Review Orbit MCBX correction budget

R. De Maria

Orbit corrector budget

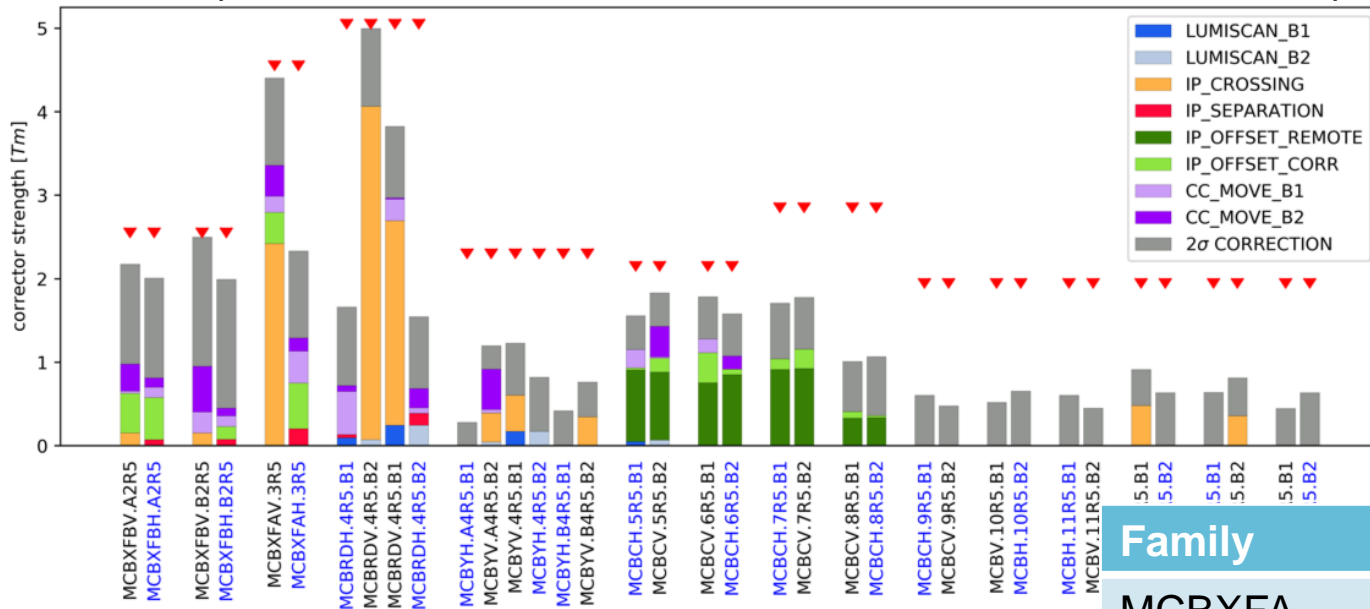
- Lumi scan: 100 μm
- IP Crossing: 295 μrad
- IP Separation: 0.75 mm
- IP Offset FRA: 2 mm
- IP Offset Corr: 0.5 mm
- CC Move: 0.5 mm
- 2σ CORR: 0.5 mm transverse - 0.1 mrad roll

FRAS is already considered in the budget to

- Shift Q1-Q5 L/R (and therefore the IP) to follow the detector ground motion (2 mm)
- Absorb yearly ground motions in the tunnel to keep the elements aligned (>0.5 mm)

Worst case

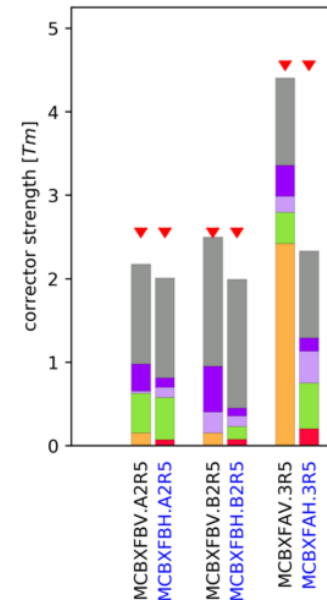
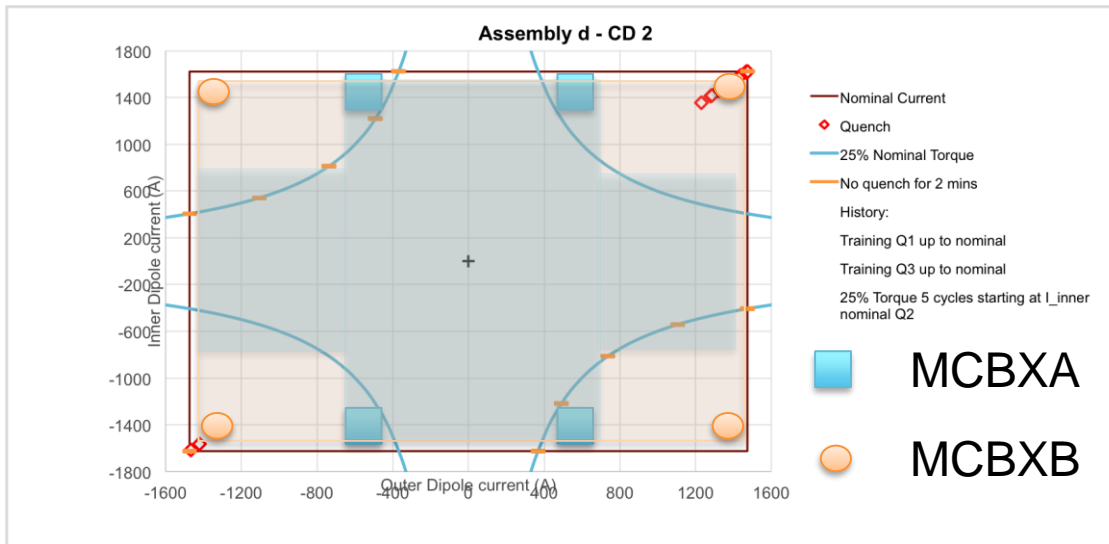
Assuming 25% of the torque is a limit:

- MCBXB limited in a circle of 1.15 Tm, missing ~1Tm
- MCBXA limited in to 1.5 Tm in non-crossing, missing about ~1Tm

The working point of MCBXB and the non crossing angle part of MCBXA is not know a priori before beam commissioning.

Possible strategy: correct at injection, train MCBX on a line, correct at flat top.

NB: yellow part of MCBXA is larger at pre-squeeze $\beta^* > 50$ cm (0.4Tm at $\beta^* = 1$ m)
